**GULF STATES UTILITIES COMPANY**

River Bend Station-Unit 1  
Docket No. 50-458

Enclosed is a revision to Chapters 13.1, 13.2, 13.4 and 13.5 of Gulf States Utilities Company (GSU) River Bend Station (RBS) Final Safety Analysis Report (FSAR). These revisions are the reflection of the organizational changes effective December 10, 1985 and will be incorporated into the next FSAR Amendment.

## ATTACHMENT 1

FIGURE 13.1-1

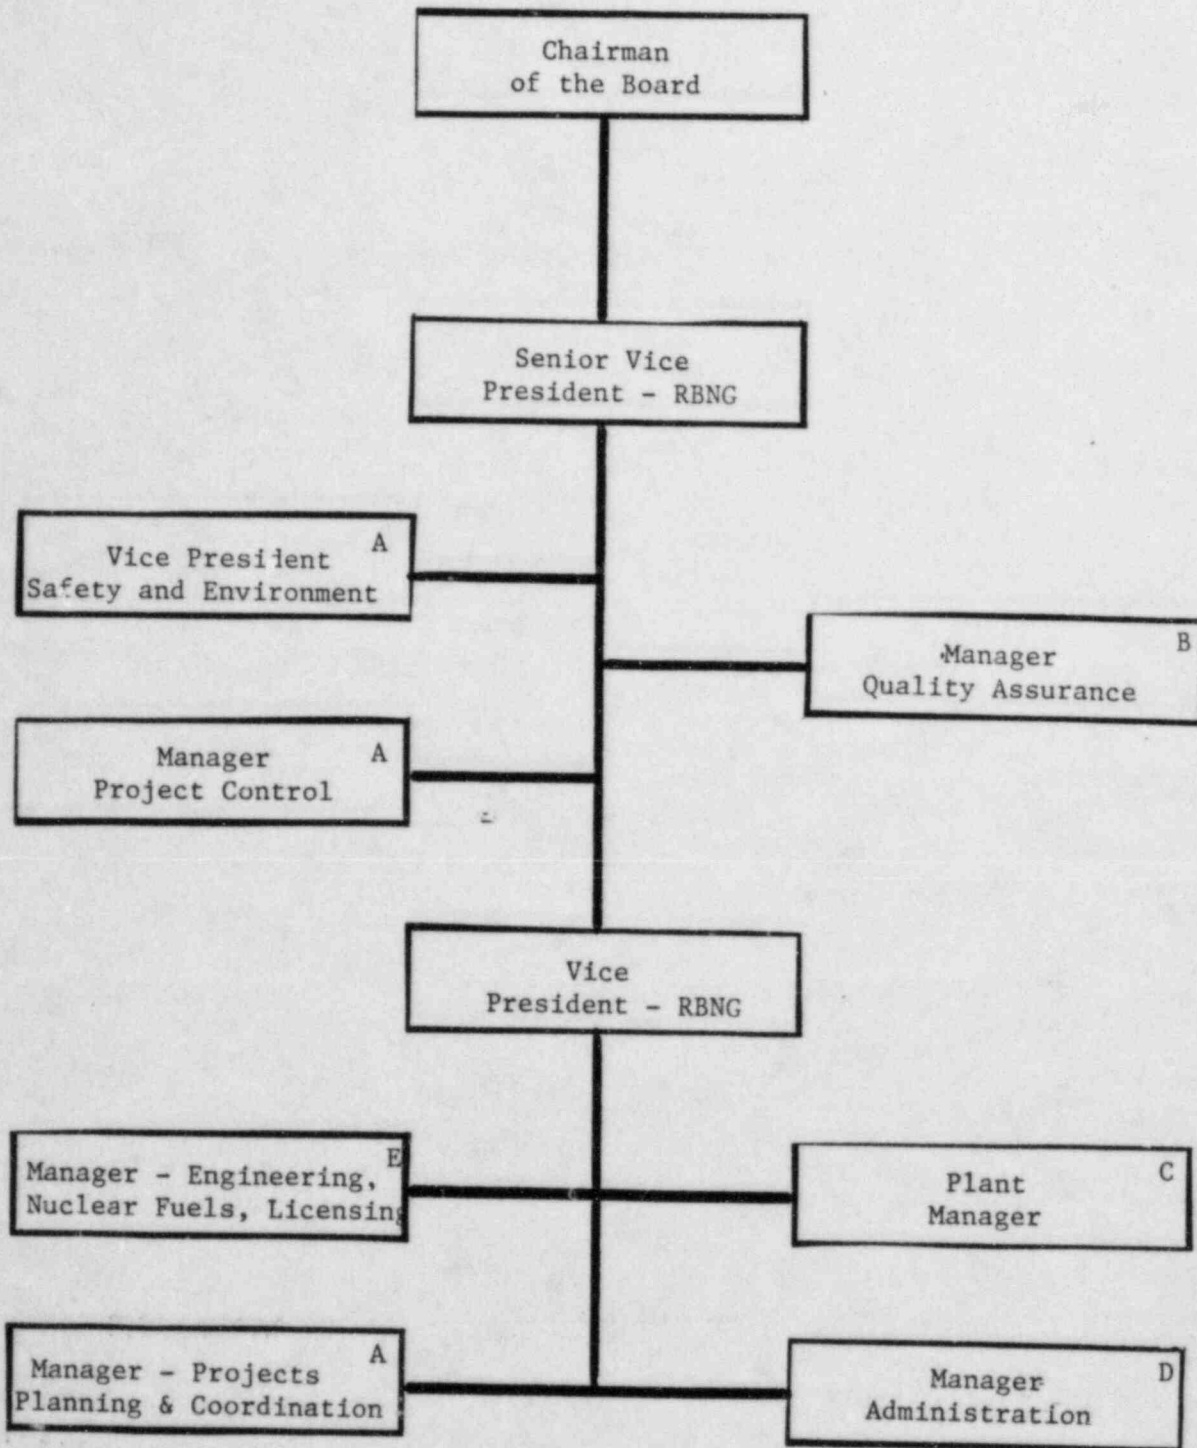
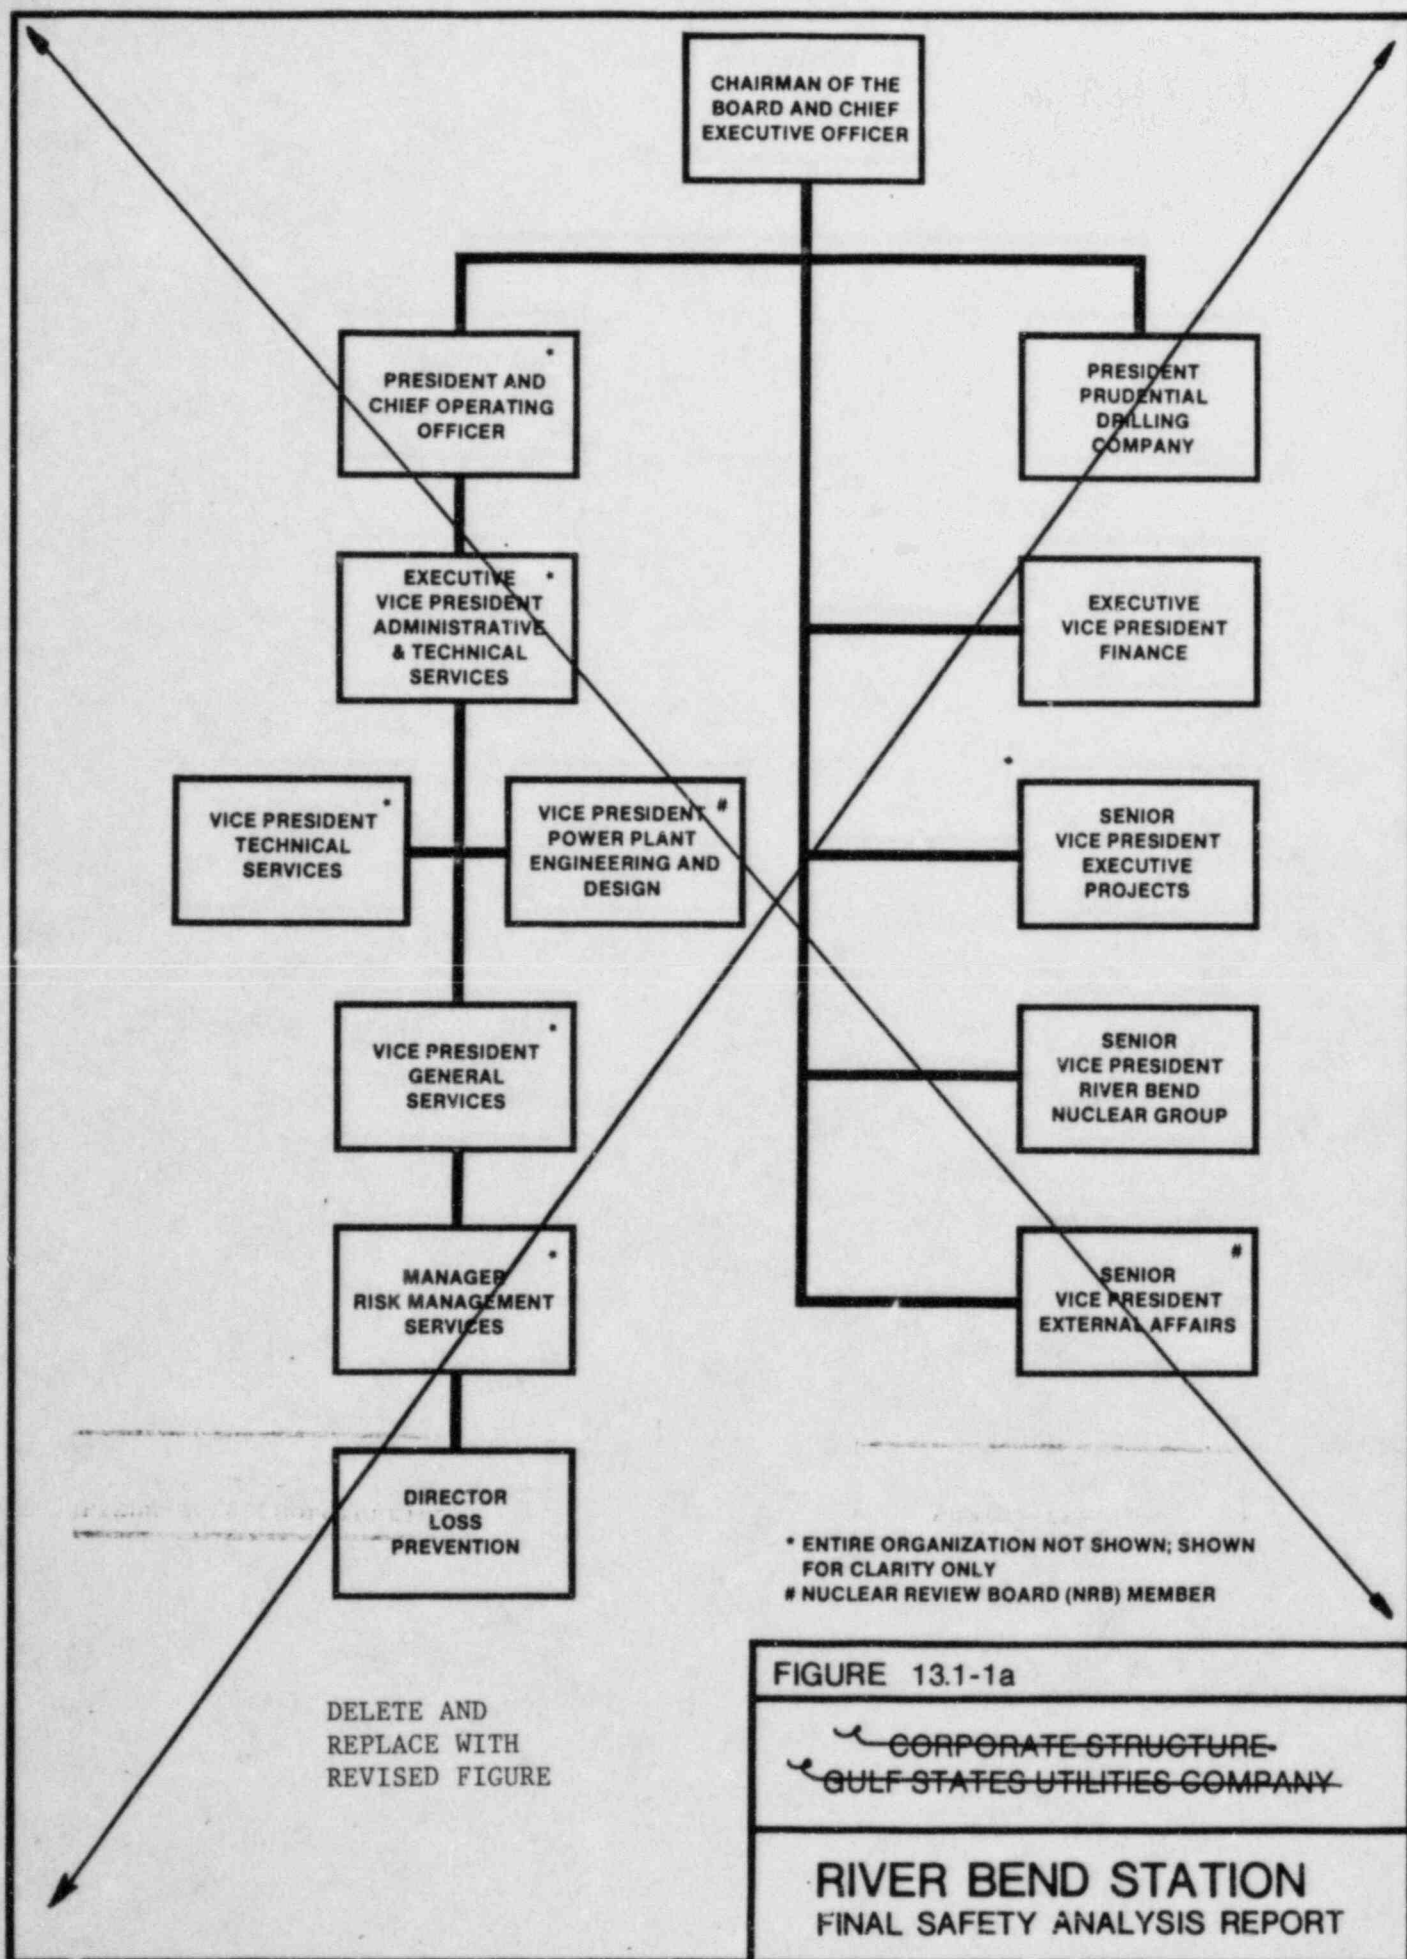
~~CORPORATE STRUCTURE~~  
~~RIVER BEND STATION UNIT 1~~

Figure 13.1-1  
River Bend Nuclear Group  
Management Structure

FIGURE 13.1-2

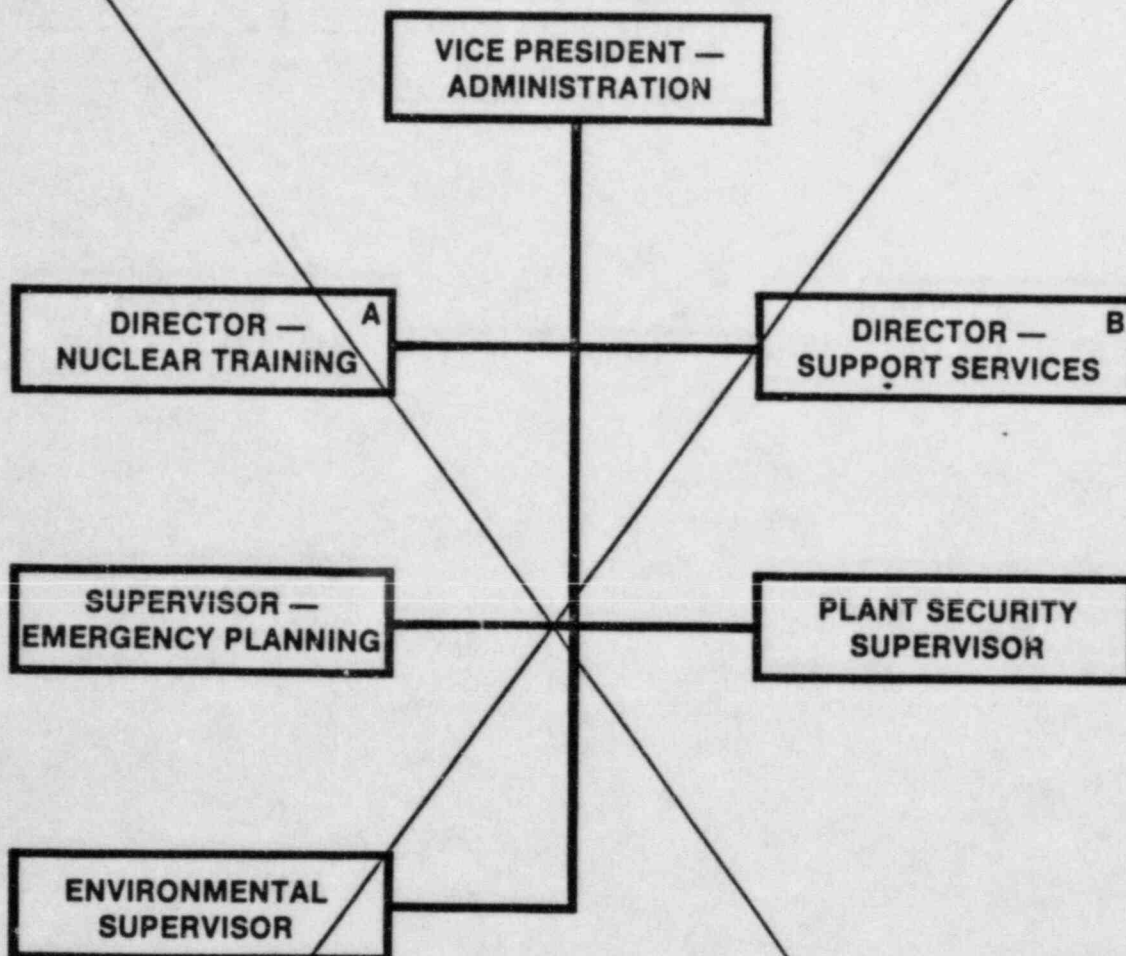
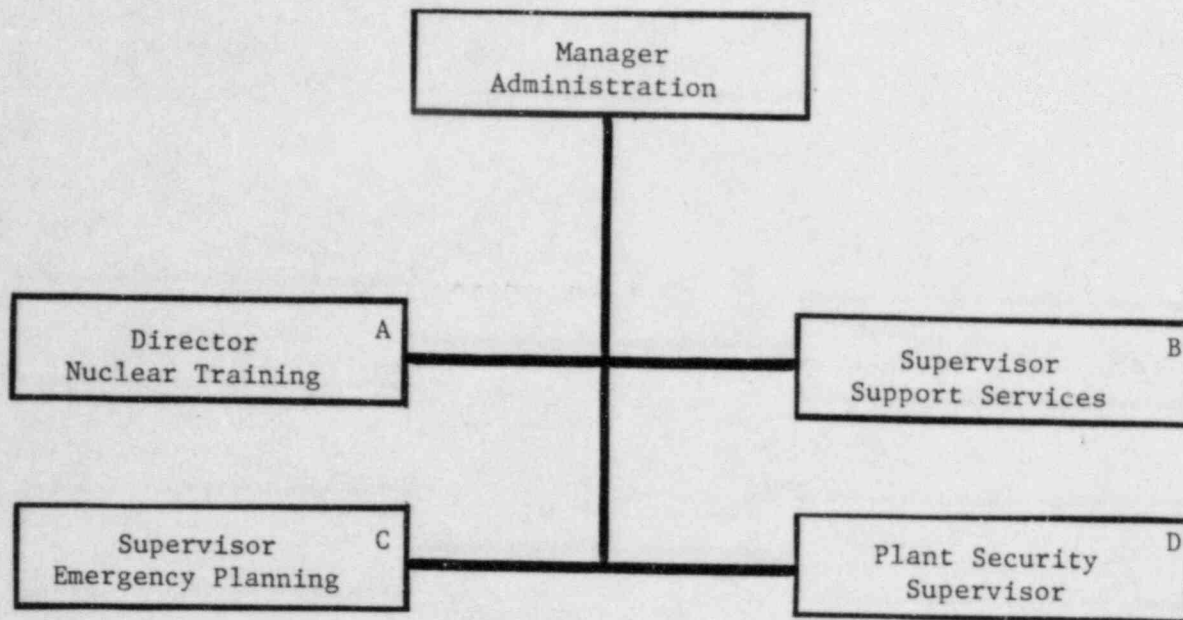
DELETE AND  
REPLACE WITH  
REVISED FIGURE

~~PLANT ADMINISTRATIVE STRUCTURE —  
RIVER BEND STATION — UNIT 1~~

Figure 13.1-2  
River Bend Nuclear Group  
Administrative Structure

FIGURE 13.1-2a

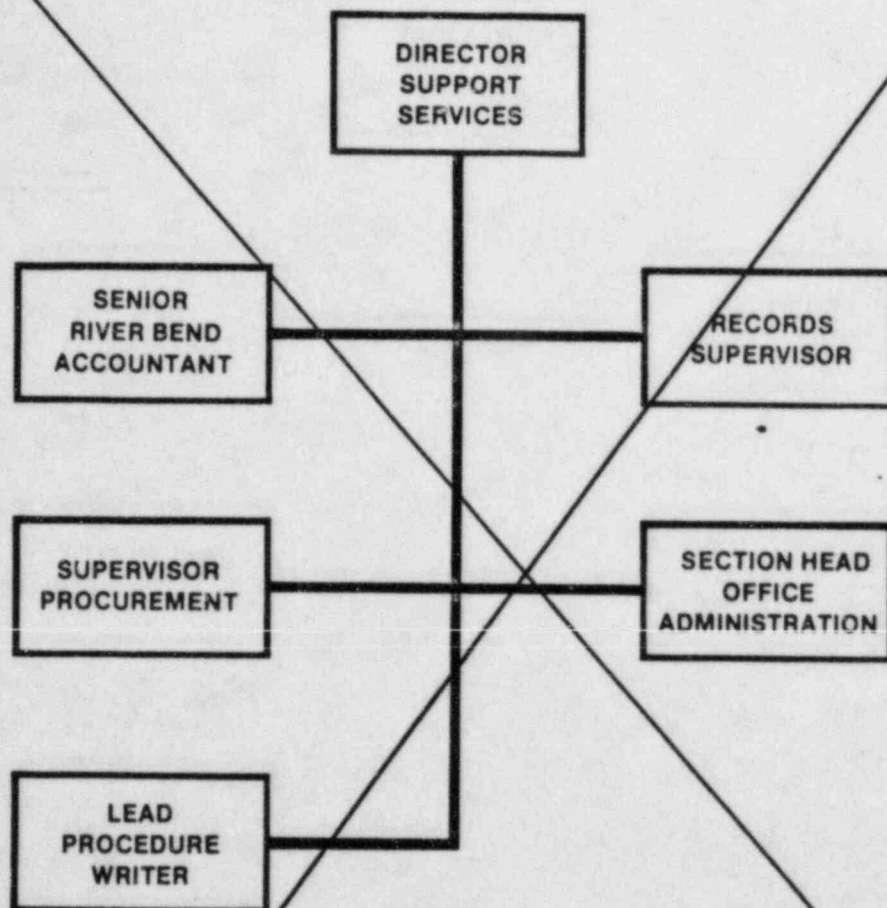
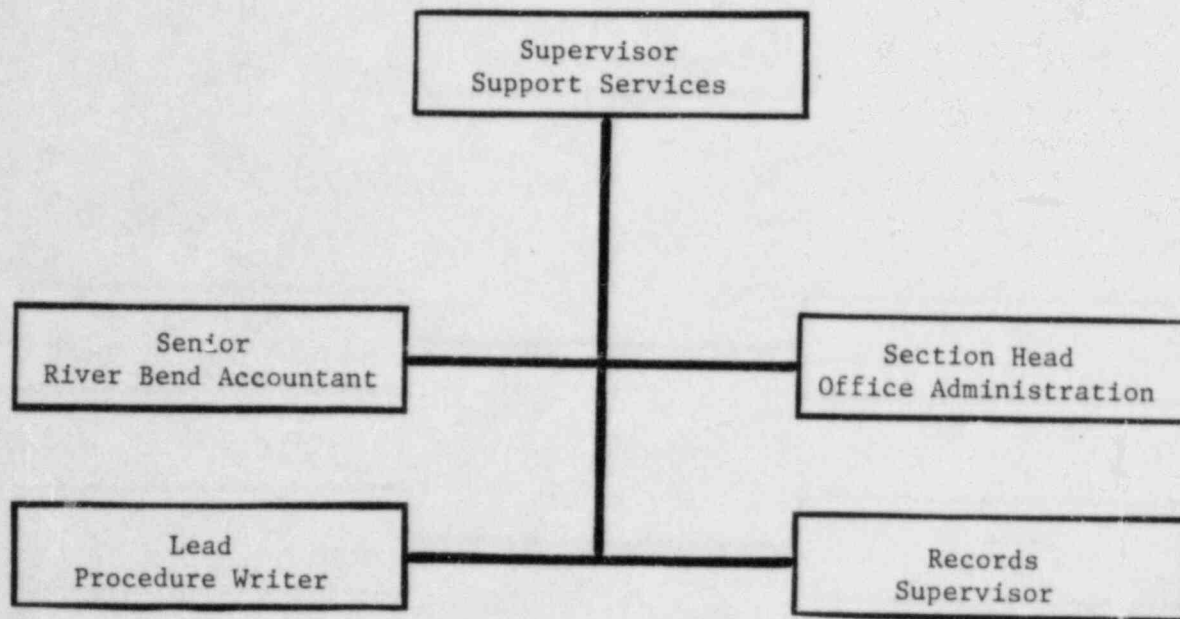
DELETE AND  
REPLACE WITH  
REVISED FIGURE

~~PLANT ADMINISTRATIVE STRUCTURE~~  
~~SUPPORT SERVICES SECTION~~

Figure 13.1-2a  
RBNG Administrative Structure  
Support Services Section
